HUDSON LOGISTICS CENTER

SP #12-22

Staff Report #4

From the Site Plan Application: Proposed redevelopment of Property for a warehouse and distribution facility, representing a reduction of the scope of the approved Hudson Logistics Center originally approved by Site Plan Decision (SP #04-20) issued on May 5, 2021 for redevelopment of three (3) buildings having a footprint collectively consisting of 2,614,984 s.f., to a single building having a footprint of approximately 1,393,822 s.f. for warehouse, distribution, and associated uses and structures on a single 375.37-acre lot, along with access driveways, parking, stormwater/drainage, and other utility infrastructure, along with lighting, landscaping and other improvements shown on the plans.

Project No. 151010101	Drawing No. CU205
Date 11/18/2022	
Drawn By MPG	
Checked By FH

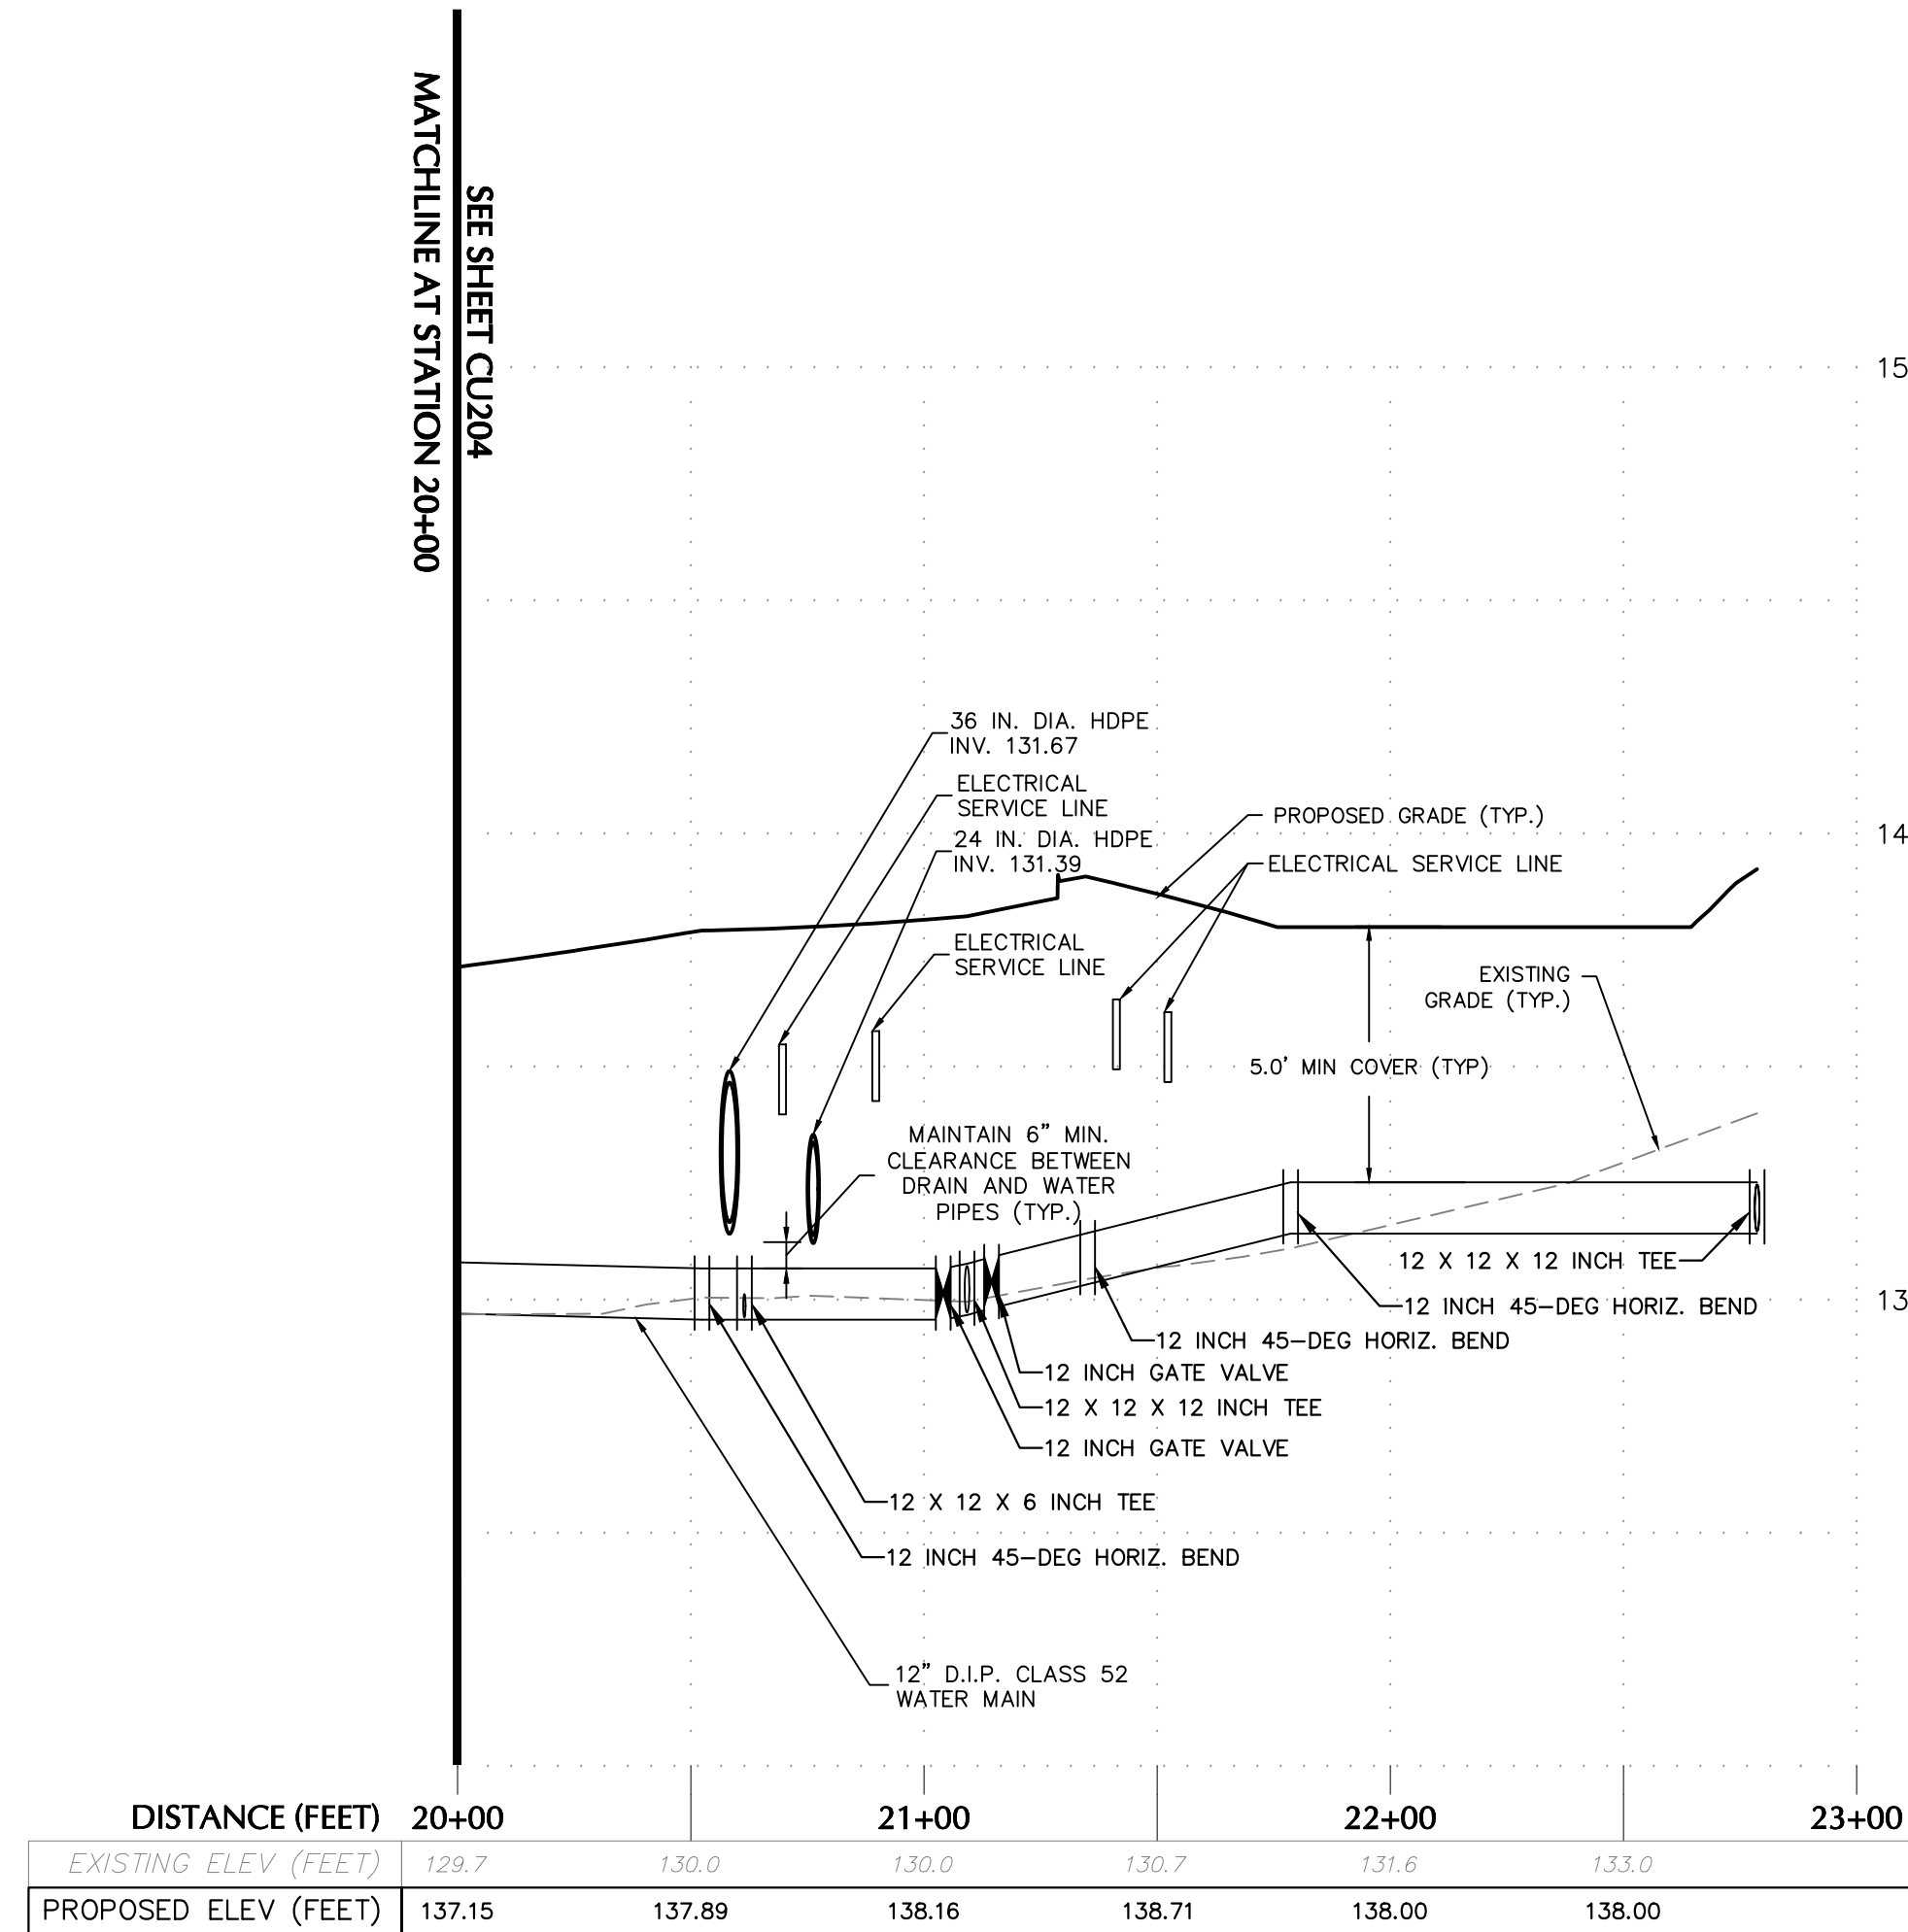
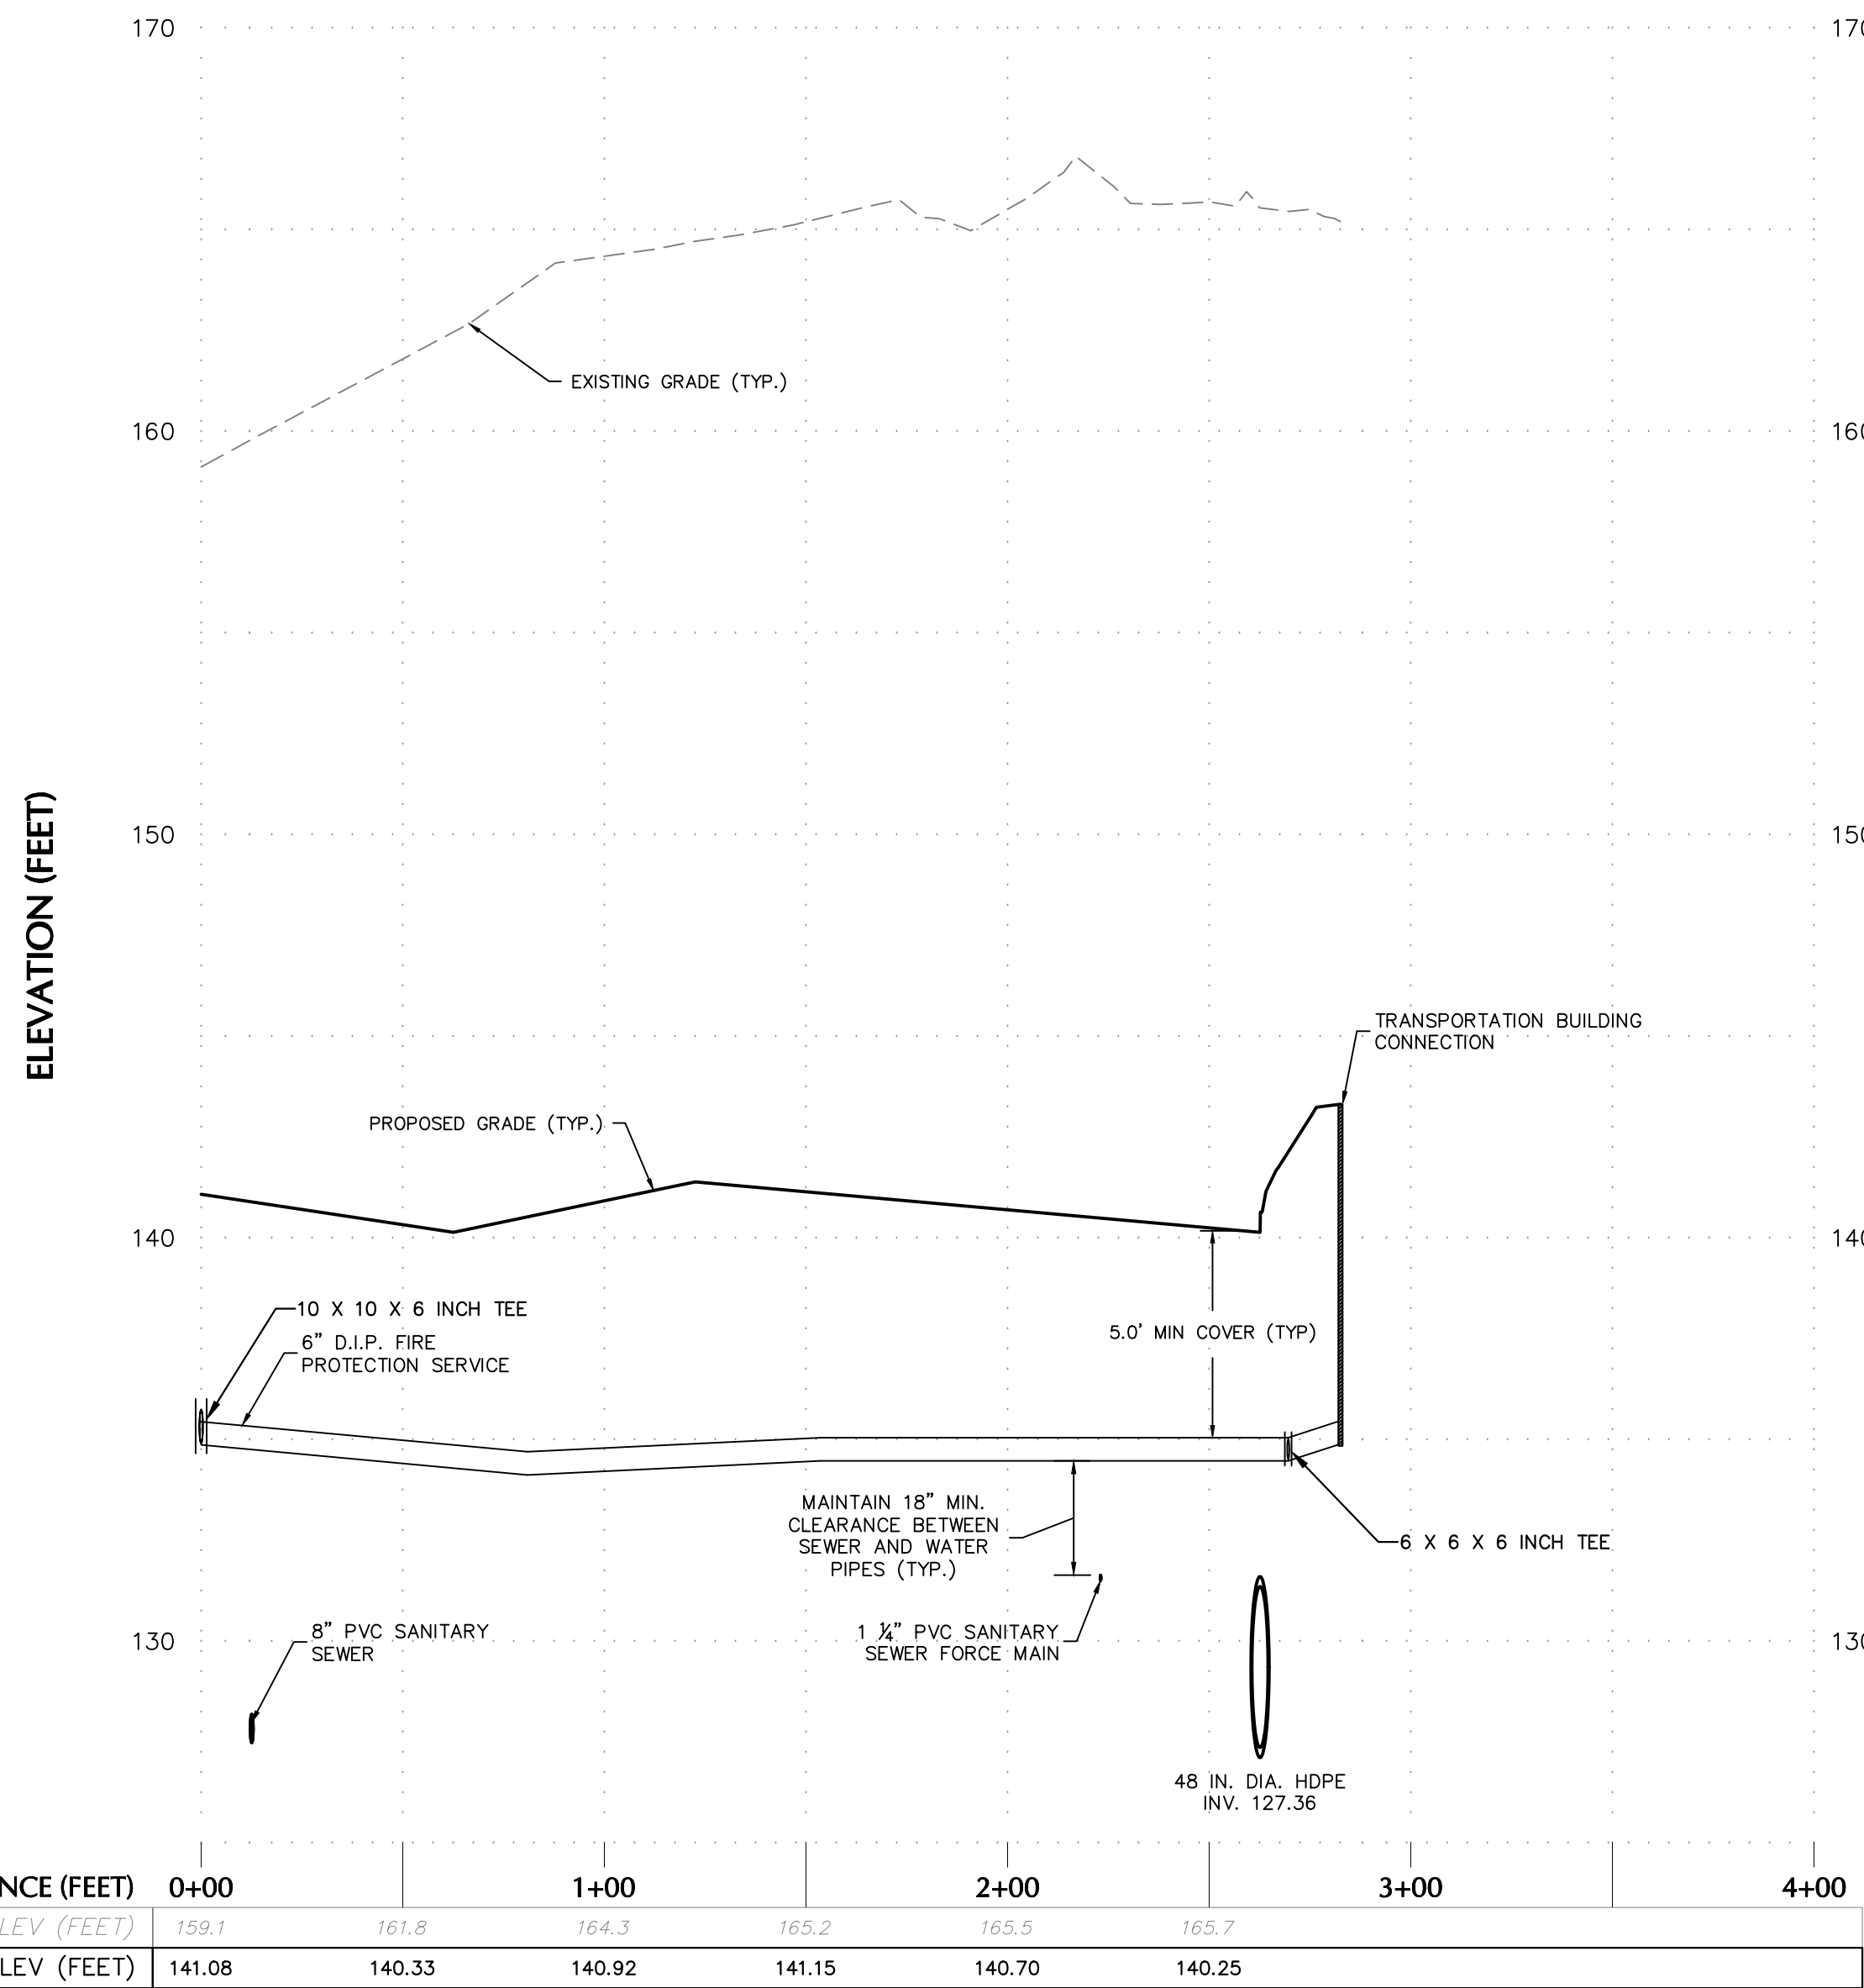
SHEET CU205 – EAST ACCESS ROAD WATER PROFILE

LANGAN COMMENT RESPONSE: This tee and valve cluster has been adjusted, revised drawings CU112 and CU205 is attached for reference.

Drawing Title
GUARD HOUSE WATER PROFILE

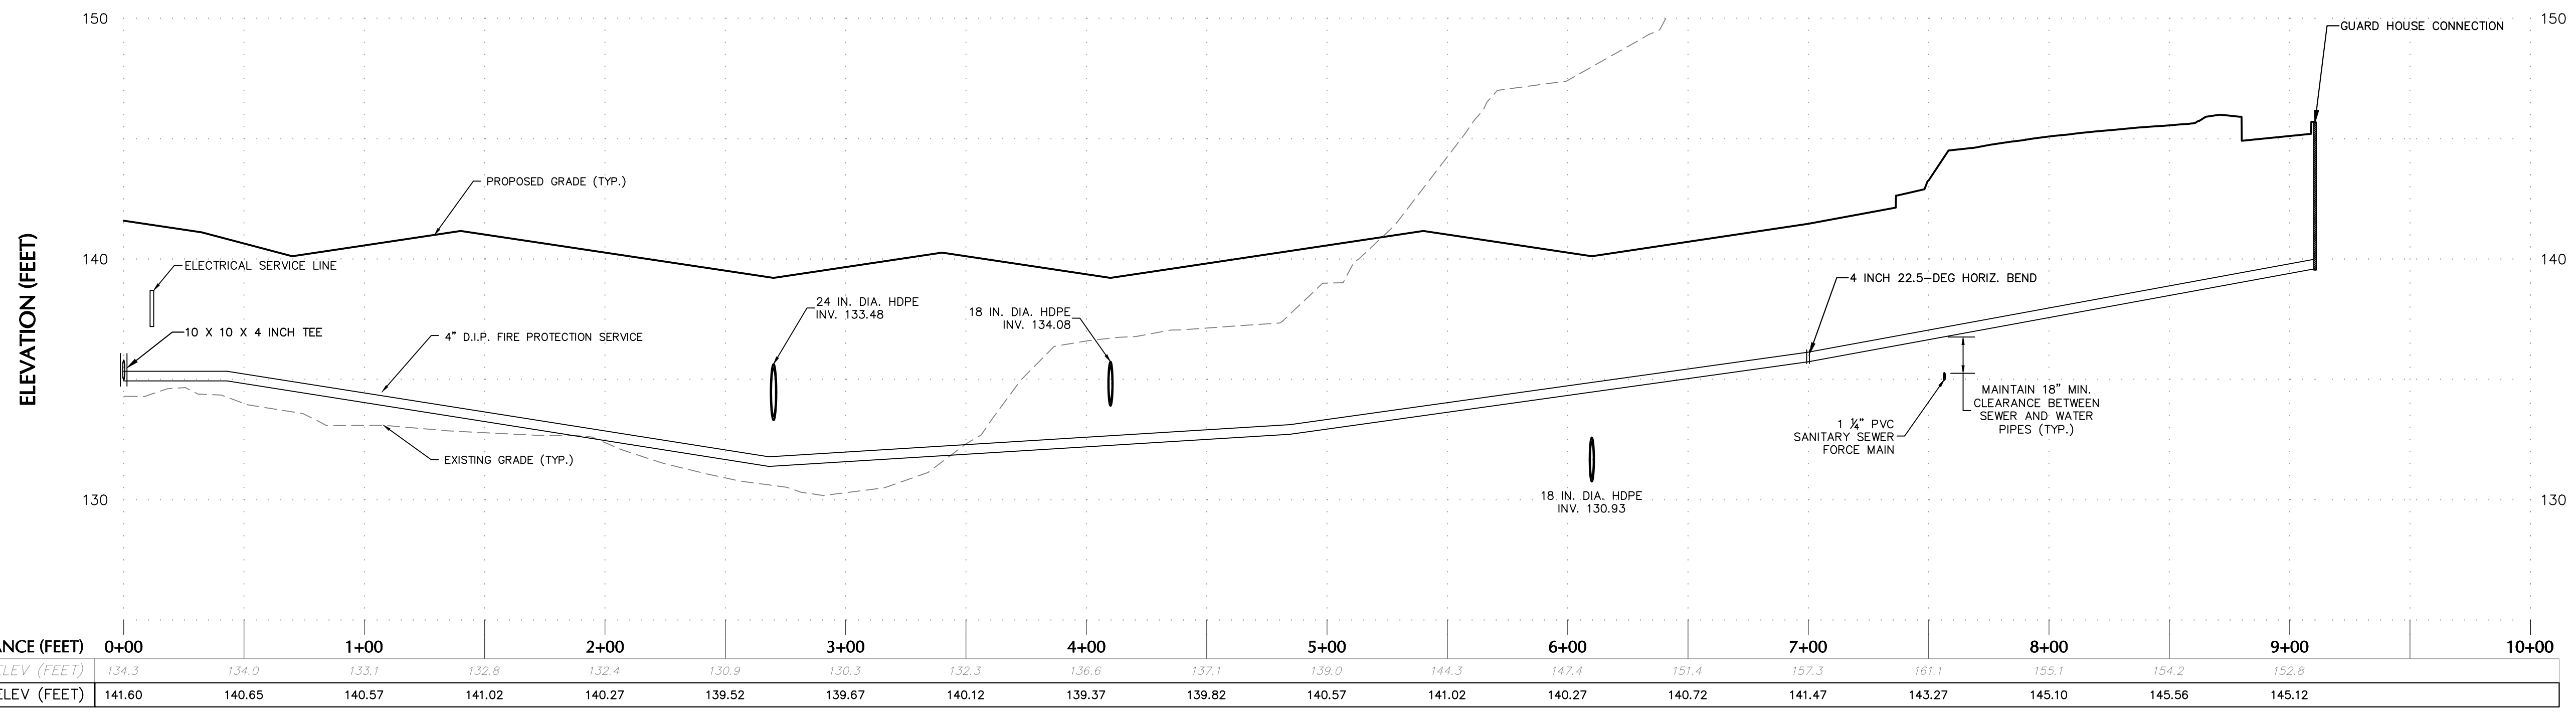
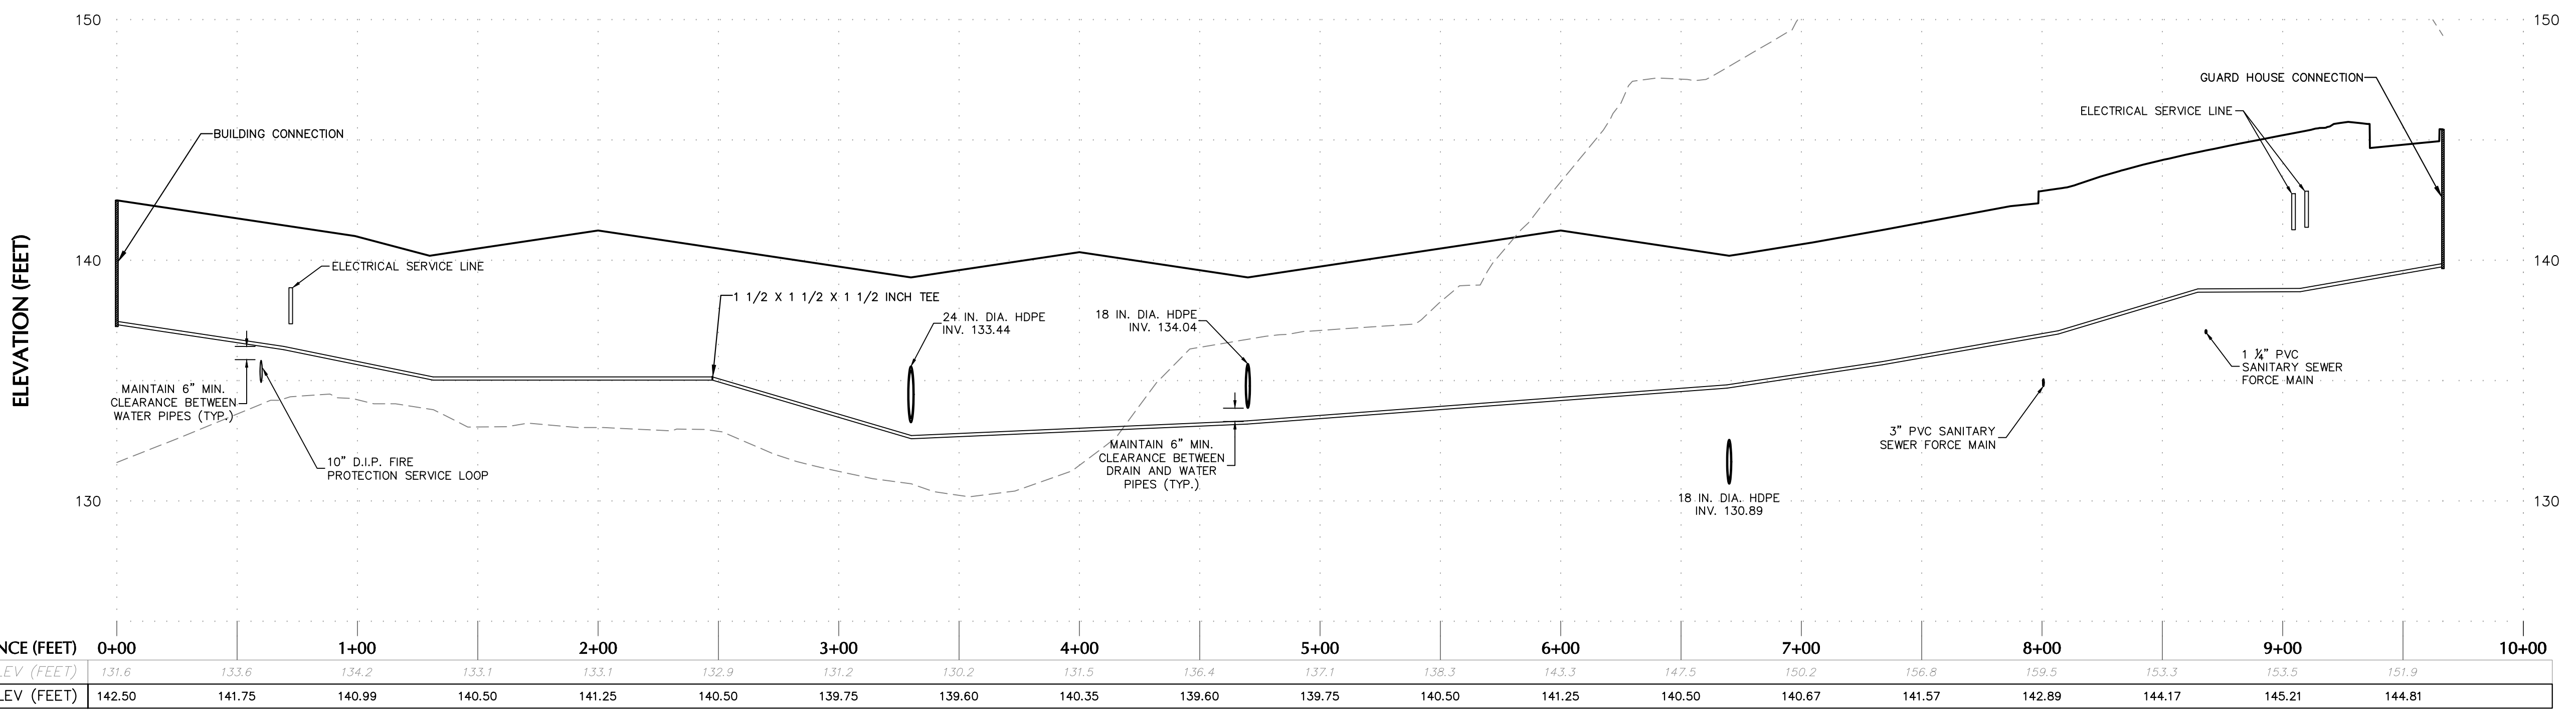
SHEET CU214 – GUARD HOUSE WATER PROFILE

LANGAN COMMENT RESPONSE: Drawing CU107 and CU214 have been edited, clarifying that the fire protection water service is 4”.
